**NRC ADVANCED MANUFACTURING PROGRAM (AMP)
WINNIPEG, MB**

<u>Contents</u>	<u>No. of Pages</u>
Addendum No. 5	89
<u>Attachments:</u>	
Specification Section 03 35 50 Concrete Floor Finishing	3
Specification Section 07 52 00 Modified Bituminous Roofing Membrane R1	7
Specification Section 08 39 53 Blast Resistant Steel Doors and Frames	3
Specification Section 22 15 00.R1 Laboratory Gas Systems	8
23 06 40.13 Silencer Schedule	1
23 06 80.13 Cabinet, Fan Coil, and Unit Heater Schedule	2
DA-099 – PARTIAL A106 – PLAN – LEVEL 1 - WEST	1
DA-100 – 6/A800 – INTERIOR ELEVATIONS	1
DA-101 – PARTIAL A202 - RCP - LEVEL 1 - WEST	1
DA-102 – PARTIAL A203 - RCP - LEVEL 1 - EAST	1
DA-103 – 19/A850 – WASHROOM	1
DA-104 – 25/A850 – WASHROOM	1
DA-105 – Partial A106 – Plan – Level 1 – West	1
DA-106 – 2/A301 – West Elevation	1
DA-107 – 2/A601 – Plan Details – West	1
DA-108 – 3/A601 – Plan Details – West	1
DA-109 – 12/A601 – Plan Detail – West	1
DA-110 – 18/A601 – Plan Details – West	1
DA-111 – A351 – Window Type Schedule	1

1 PARTIAL FOUNDATION PLAN - EAST
- DS.015 SCALE: 1 : 100

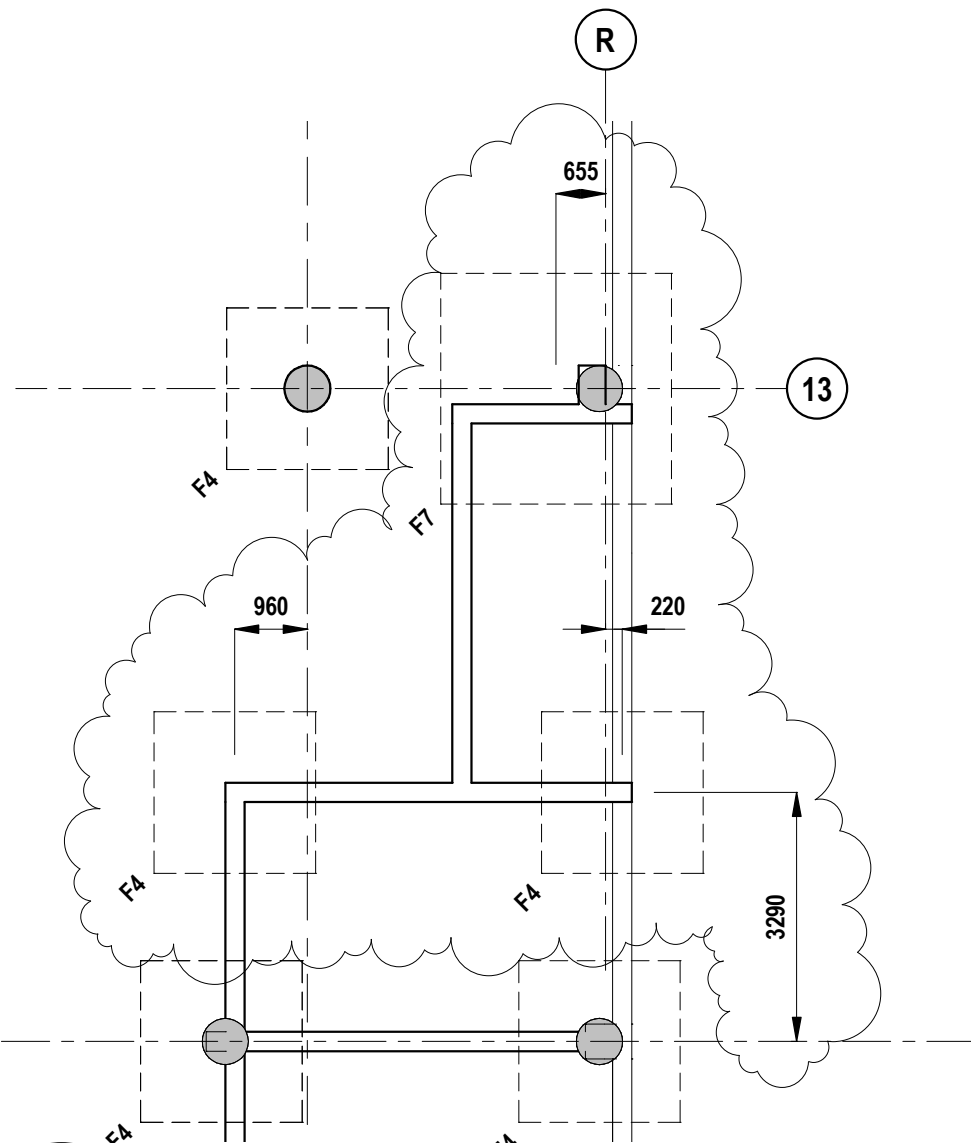
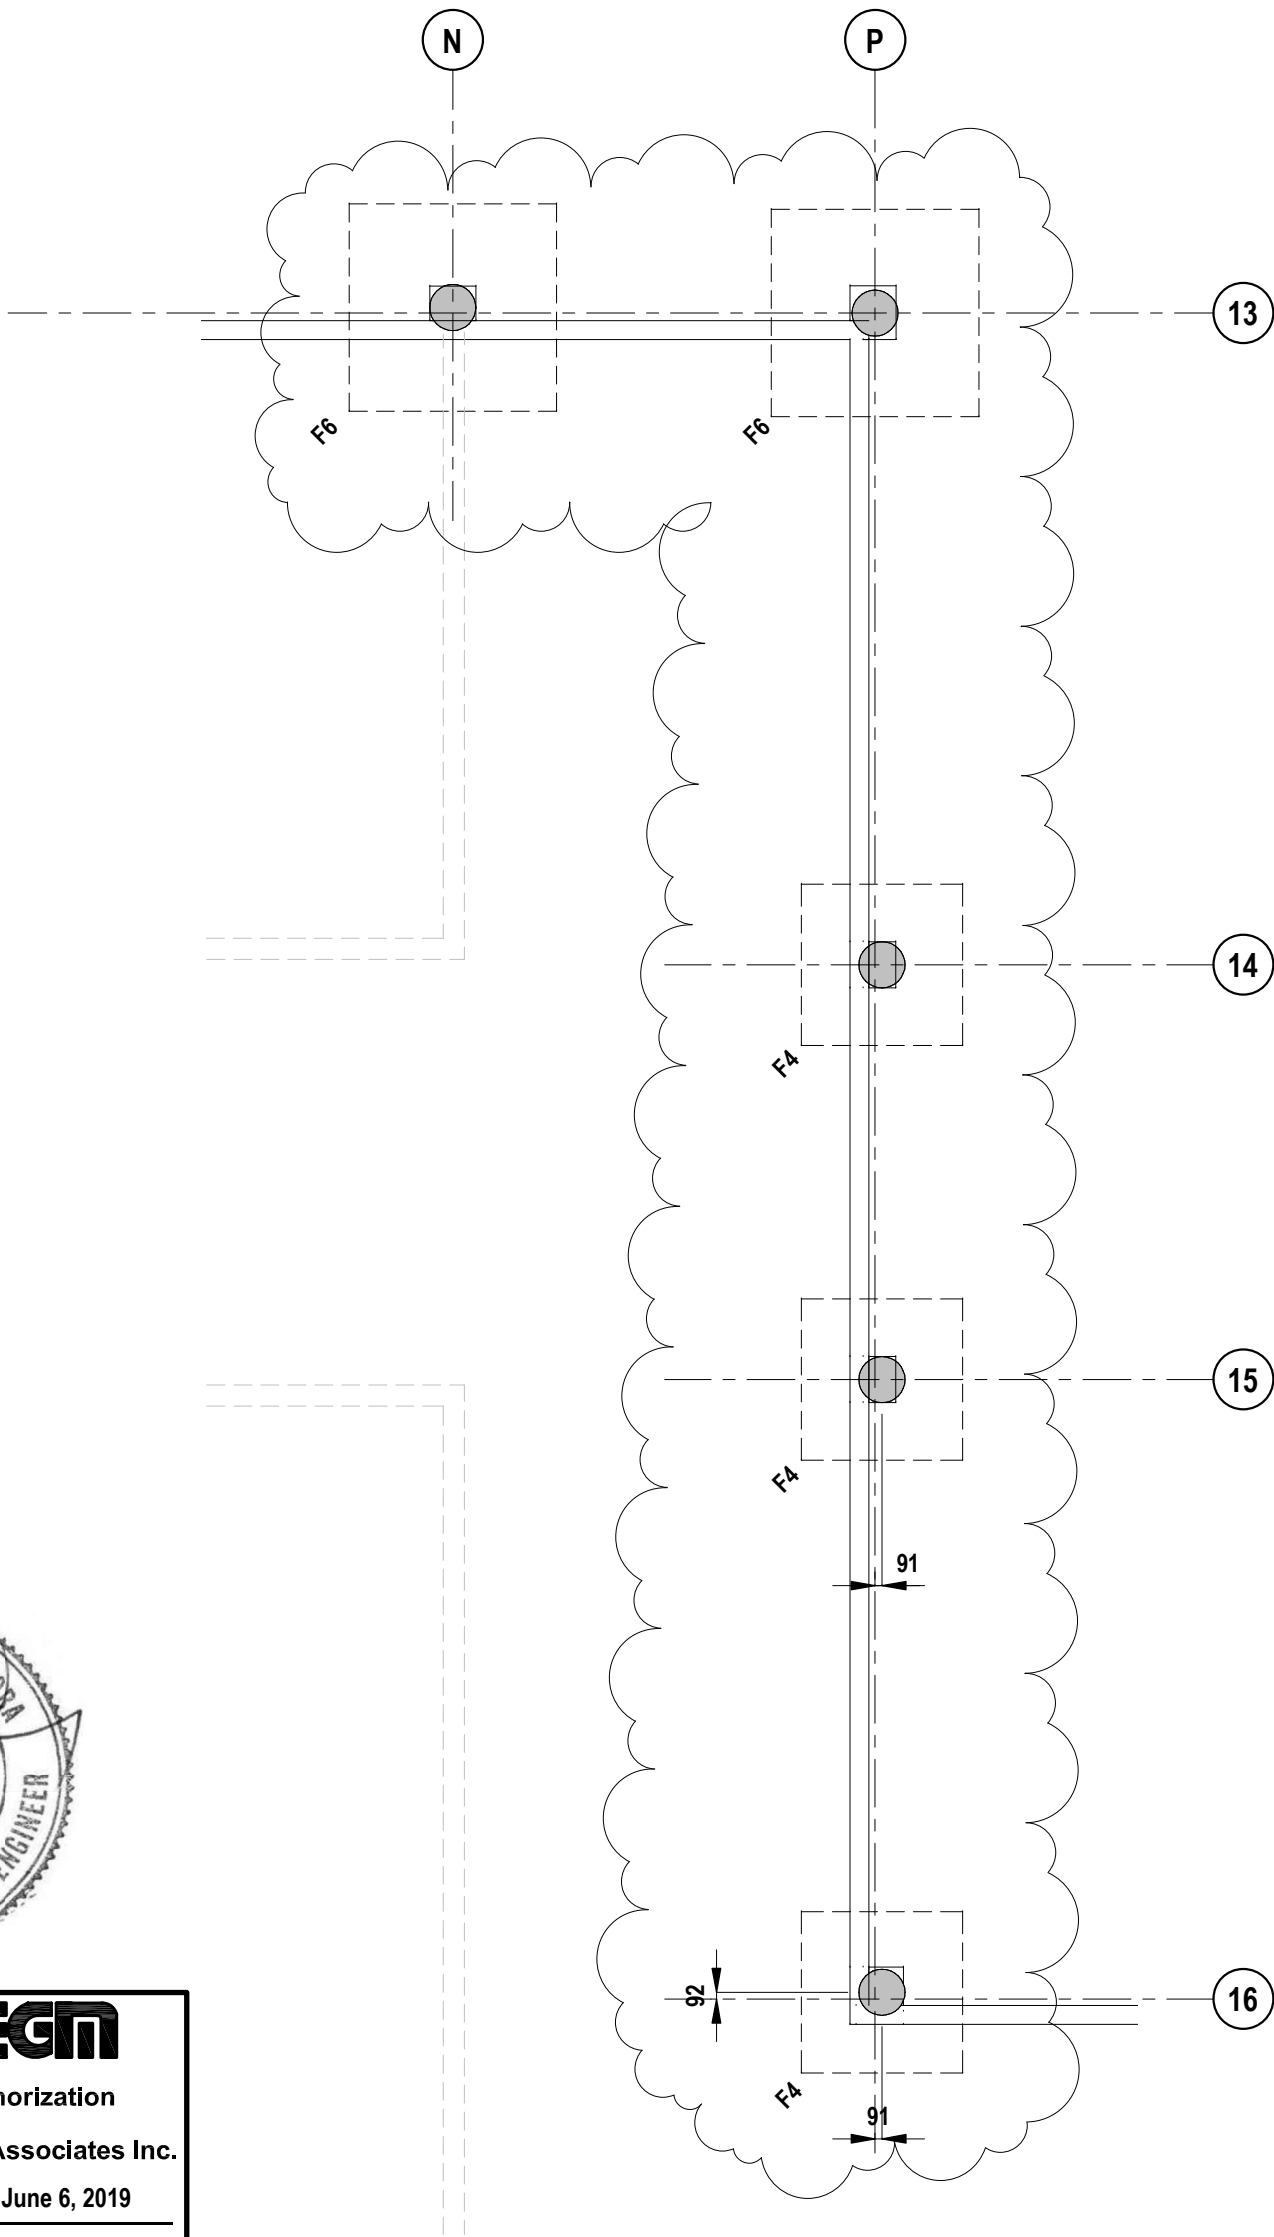
- 7.1 Refer to Drawing S101, S102:
.1 Refer to attached detail sheets DS.015, DS.016, DS.017 and DS.018 for foundation revisions.
- 7.2 Refer to Drawing S121:
.1 Refer to attached detail sheet DS.021 for relocation of grade beams on grids 3 and 7 and addition of base plates and pilasters for columns on grid A/A.1.
.2 Refer to attached detail sheet DS.022 for new base plate and pilaster details.

PARTIAL LEVEL 1 FLOOR FRAMING PLAN - WEST

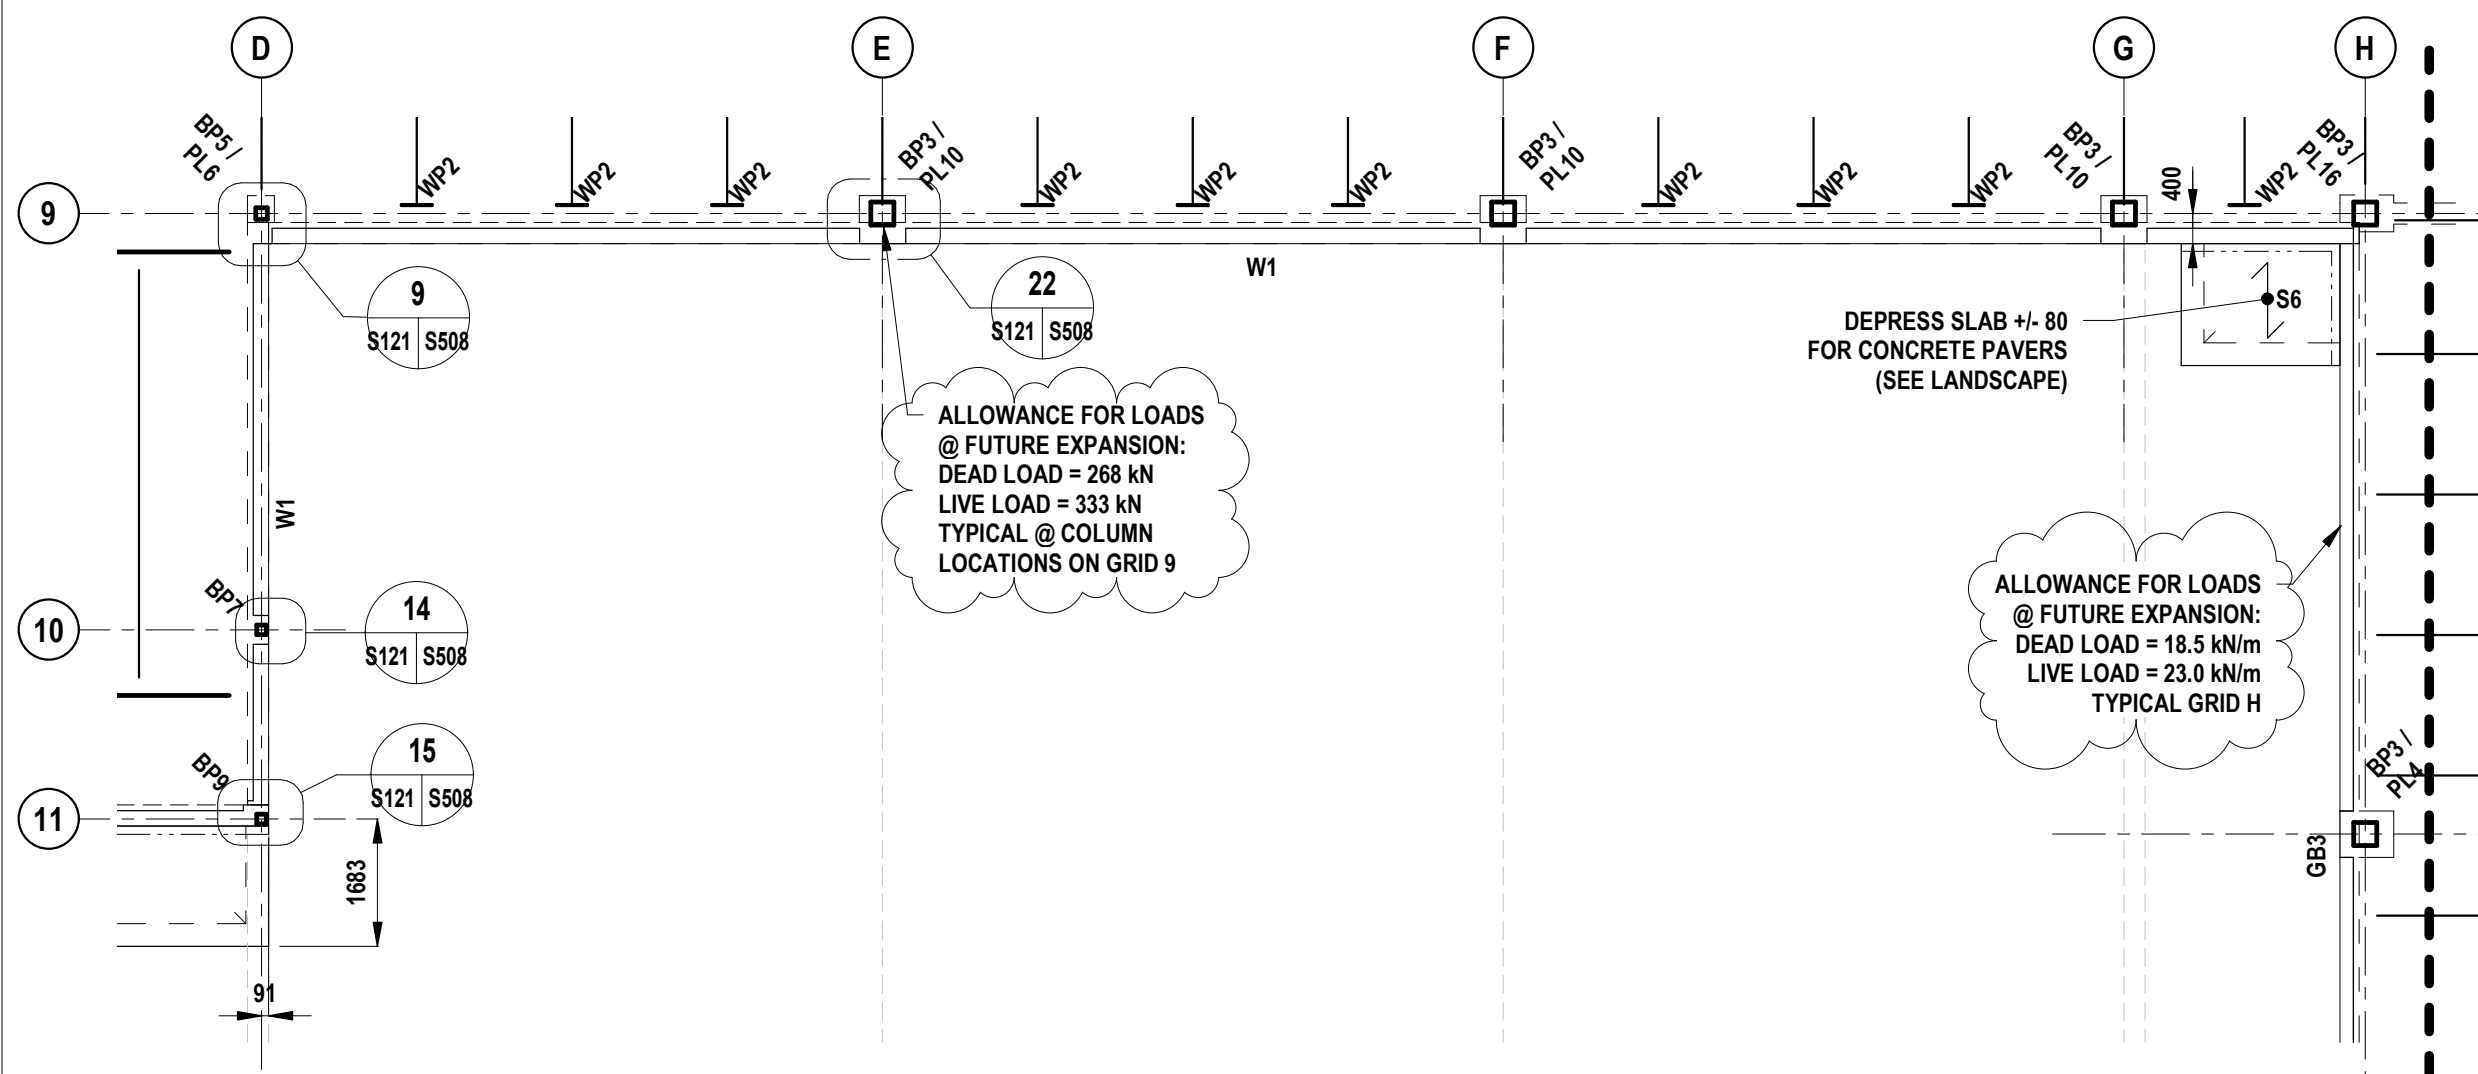
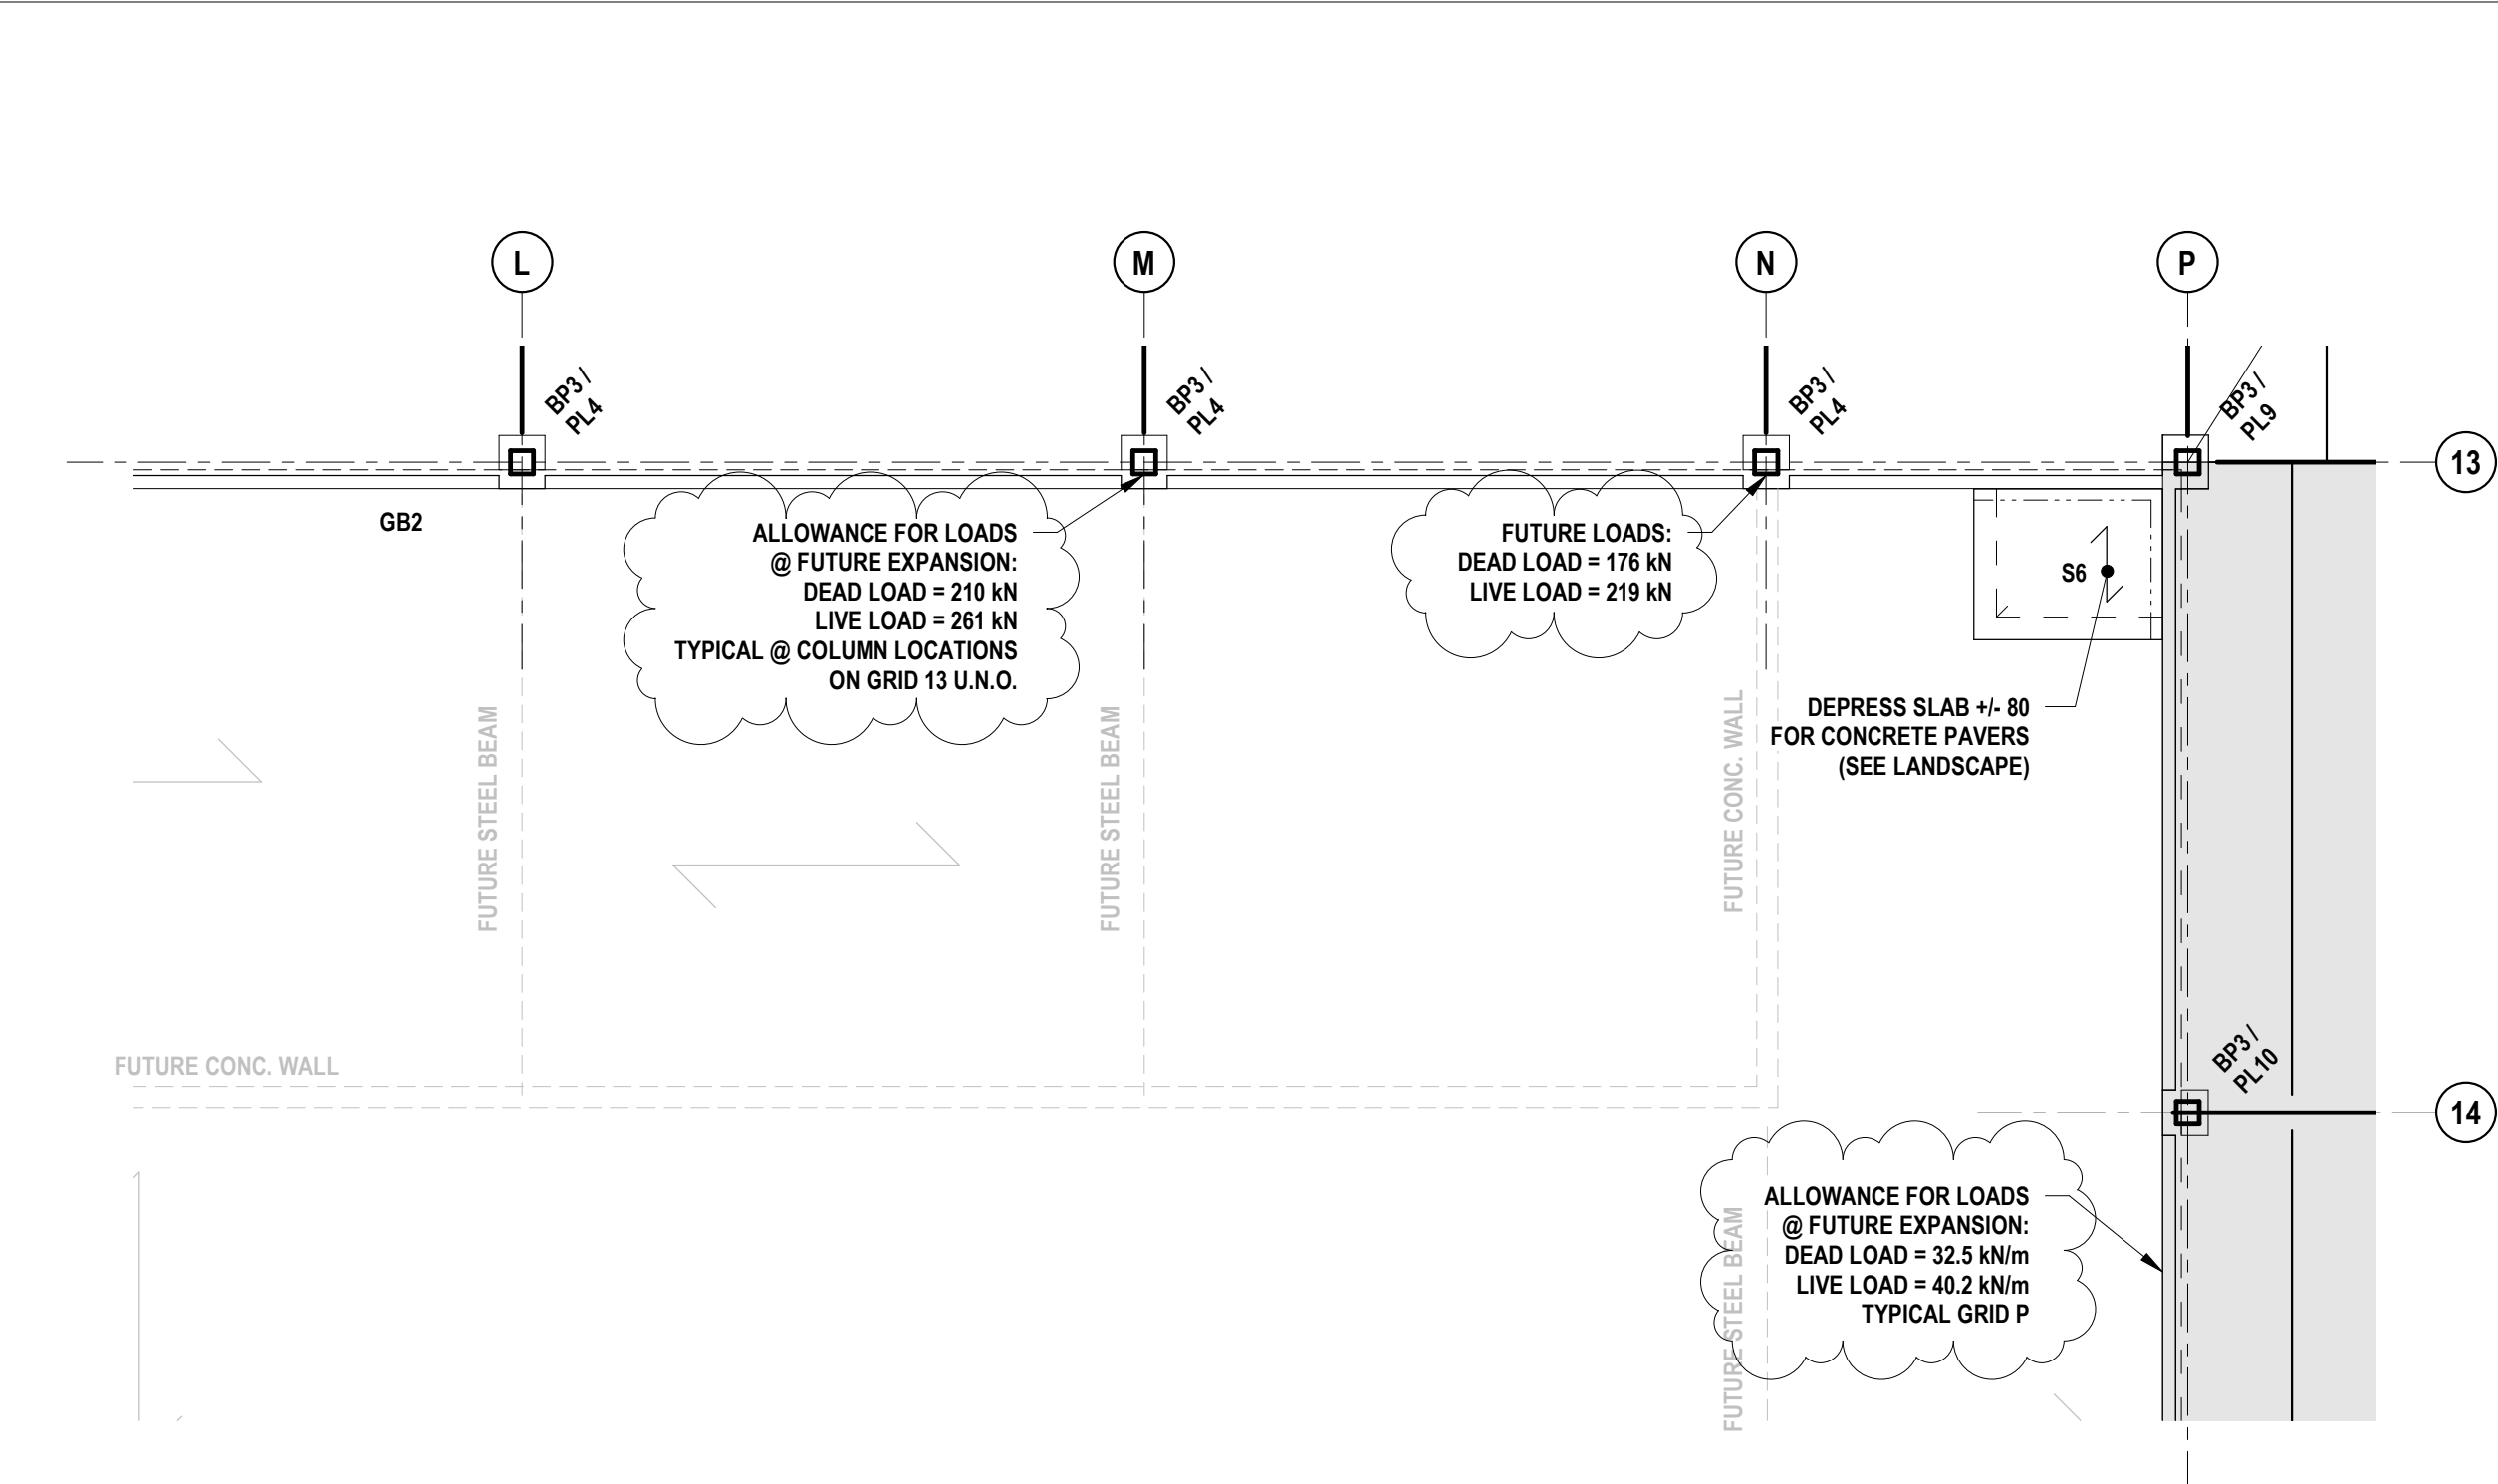
- 7.3 Refer to Drawings S121, S122:
.1 Refer to attached detail sheets DS.019 and DS.020 for clarification of loading at future expansion on Level 1.
- 7.4 Refer to Drawing S131:
.1 Refer to attached detail sheet DS.025 for clarification of loading at future expansion on Level 2.
.2 Refer to Drawing S131; refer to steel beams spanning between grids A.1 and B, from grid 1 to 3; revise beams from C200x17 to W200x31. W610x125 on grid 2 to remain as is.
